Item **PP03** - REPORTS - **14/08/19**

ADDRESS/WARD: 173-179 Walker Street & 11-17 Hampden Street, North Sydney (W)

PROPOSAL NO: 3/19

AUTHOR: Brett Brown, Director Ingham Planning Pty Ltd (Independent Planning Consultant)

Figure 19 – Aerial view of northern CBD and adjoining areas

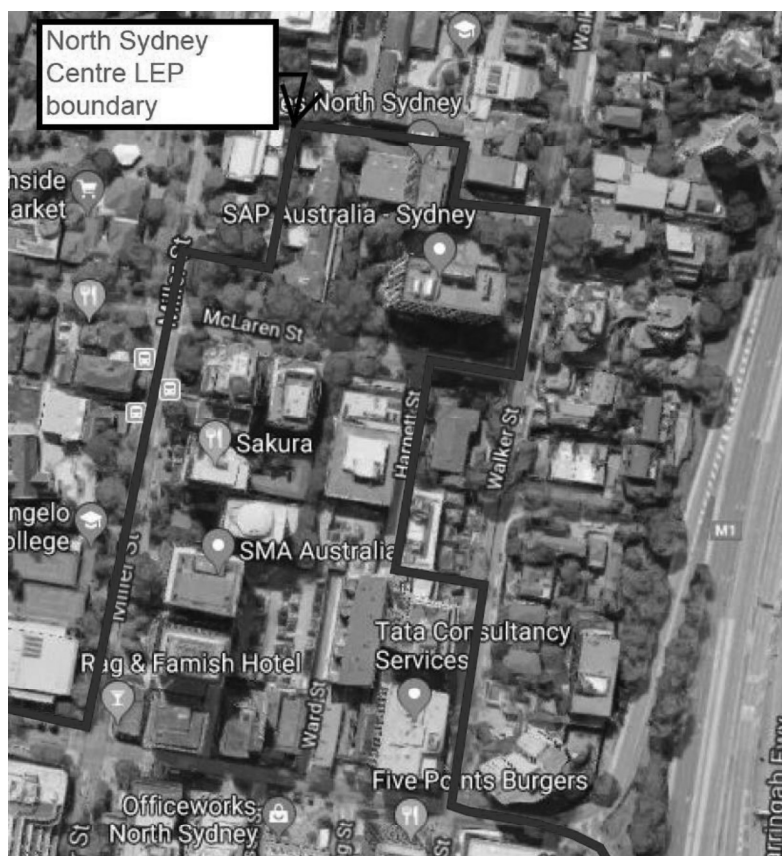
It is considered that the Planning Proposal does not adequately respond to the difference in landscape character between the CBD and adjoining areas. As can be seen in **Figure 18**, green space is far more prevalent in the areas outside the CBD than within the CBD. This is to be expected given the zoning within the CBD which is predominantly B3 Commercial Core or B4 Mixed Use. Typically development within this area is either street wall buildings (ie tall building with little or no setbacks) or podium and tower typologies. Either way there is little opportunity for landscaping within these areas.

Figure 26 – Key Principle-Height transition

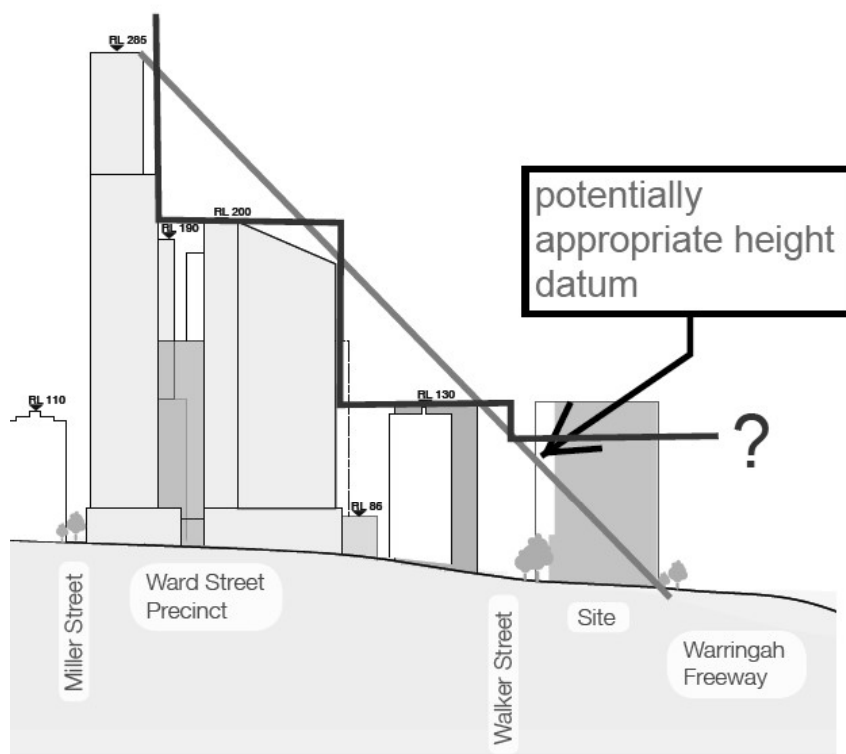
As indicated in the following figure from the applicant's Urban Design Study (**Figure 26**), the buildings used to establish appropriate building height are all separated from the site and the intervening building heights have been ignored in the consideration. To provide an appropriate transition from the CBD to the freeway, it is appropriate that the building heights on the site are lower than the building heights that already existing/are permitted on the current edge of the CBD. The 'edge' of the CBD relevant to the subject site, are the developments at 61 Berry Street (at the corner of Walker Street) to 138 Walker Street. It being noted that further to the north the Heritage Apartments and 45 McLaren Street are not part of the CBD.

The highest of the 'edge' buildings is 138 Walker Street which has an RL of 130m. The Reference Design is higher than this at RL133m. The lack of transition can be seen in **Figure 27** (taken from the Urban Design Report). To establish a reasonable transition from the taller proposed buildings to the west, through to the existing buildings on the western side of Walker Street, to the site, a green line has been overlaid to (somewhat crudely) reflect this height transition. This does not indicate an envelope but rather an appropriate datum for height over the whole site based on the Walker Street frontage. The alternative would be to consider the manner in which building heights step down from west to east (indicated by the blue line). Whilst any building should be lower than RL130m, the most appropriate height should be determined with regard to the other issues that have been raised and, if building typologies which are inconsistent with the R4 zoning are contemplated, the future outcomes of the Northern CBD Planning Study.

Figure 28 – Skyline Study-East Elevation

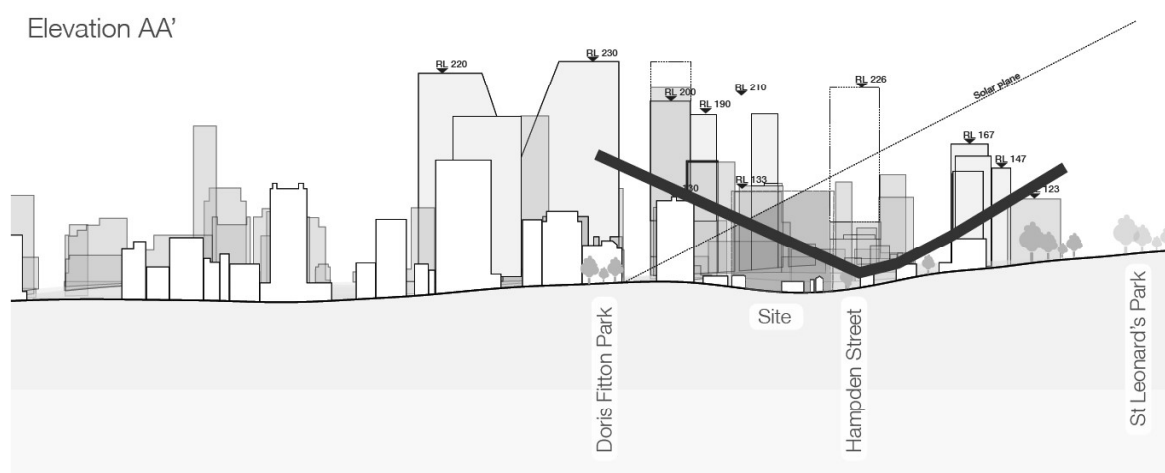
Also having regard to the north/south transition (although these areas are also outside the CBD), the following figure from the Urban Design Report (**Figure 28**) shows the height relationship with existing buildings. The blue line indicates a transitional height line.

Importantly this reflects the predominantly low scale nature of this precinct which includes the heritage items in Hampden Street. It also reflects the topography and it is important that building heights respond to this characteristic, particularly given the location of the site at the bottom of a gully.

The highest building in this north/south elevation, Century Plaza, is an anomaly in this area but is partly justified by the higher buildings in the CBD to the south and west. Notwithstanding this, given the locational attributes of the site, it would be considered unreasonable to limit the height to the blue line. Rather it should be regarded as providing a transition principle for the site, with a low scale interface being provided to the heritage buildings and other lower scale development to the north.

Figure 1

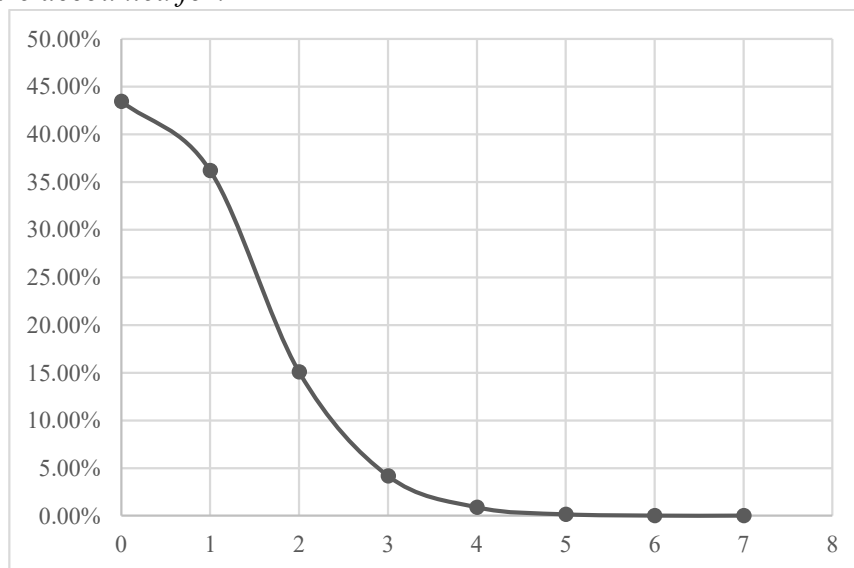
- The traffic data was collected in 2014, 5 years before the submission of the current planning proposal. Analysing the traffic situation using more recent data would be appropriate.*
- The assessment states that there will be about 1 car every two minutes and would not cause queues on Walker Street. This assumption is based on 25 cars entering the development per hour during the evening peak time. Typically, cars entering/departing a building (or intersection) exhibit a Poisson distribution. Assuming the same average entry rate: 25 cars per hour, the probability of 0-7 cars entering the building is shown in Figure 1. There is a 4.2% probability of 3 cars entering the building. This is not insignificant. Good practice in infrastructure planning dictates planners ensure extreme events are accounted for.*

- To avoid queuing and ensure access to properties on Walker Street, cars looking to turn right will have to wait before the entry into the off-street parking garage opposite the development [refer Figure 2, which co-incidentally shows where a car should wait]. In between the two markings, there is space for one car. If one were to assume that three cars enter the development in any two-minute window, the queue could build up and reach Berry Street.*

Figure 3

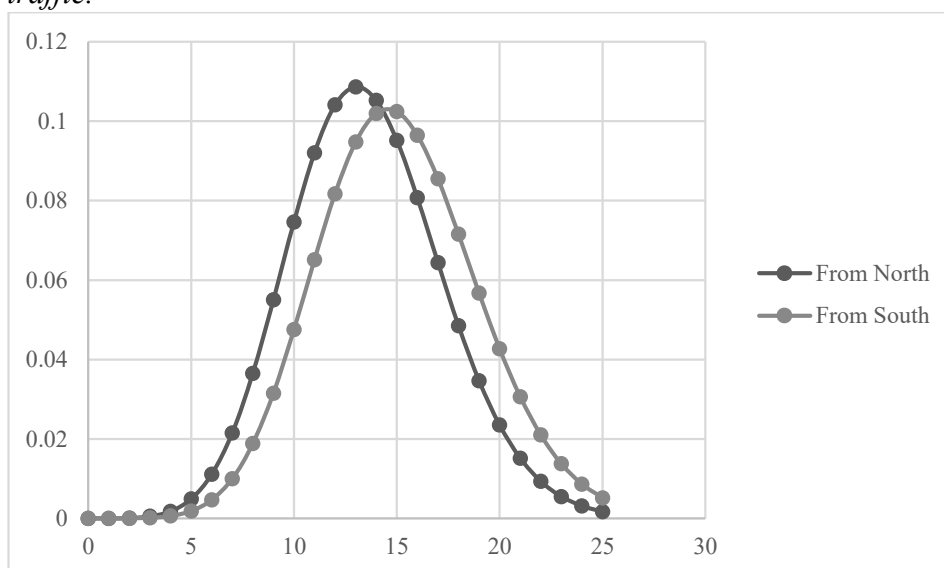
- *The movement summary data in the assessment suggests that a total of 452 vehicles approach Walker Street from the South and 407 from the north in the evening peak. Assuming a Poisson distribution (Figure 3), up to 20 vehicles could approach the development from the North, and up to 22 vehicles could approach the development from the South in any two-minute window. Intuitively, these numbers suggest that the effect of queues can be extremely detrimental to the operations of the road.*

As noted earlier, the applicant should analyse for the possibility of 3 cars queuing. The cars cannot queue on the entries to the surrounding buildings, which affects overtaking for through traffic.

Figure 4

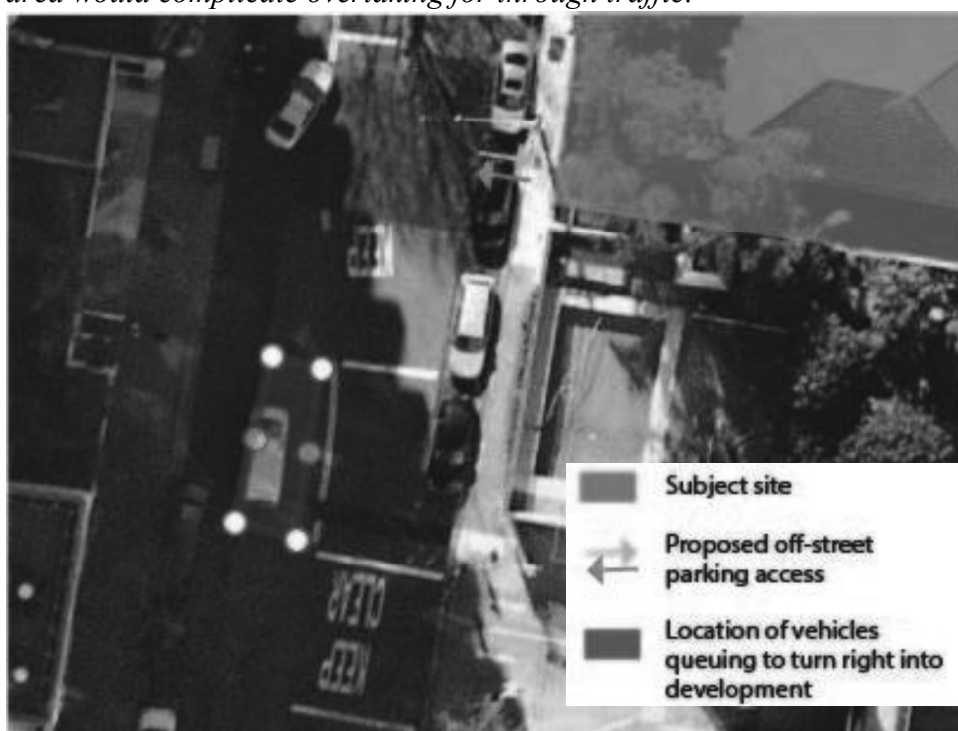
- The figure on page 24 of the TIA suggests that it is possible for vehicles to overtake vehicles waiting to turn right into the development. This assumes only one vehicle will be waiting. It would more appropriate to plan for three vehicles queuing up to turn right. Nevertheless, vehicles would queue as shown in Figure 4. The on-street parking next to this area would complicate overtaking for through traffic.*
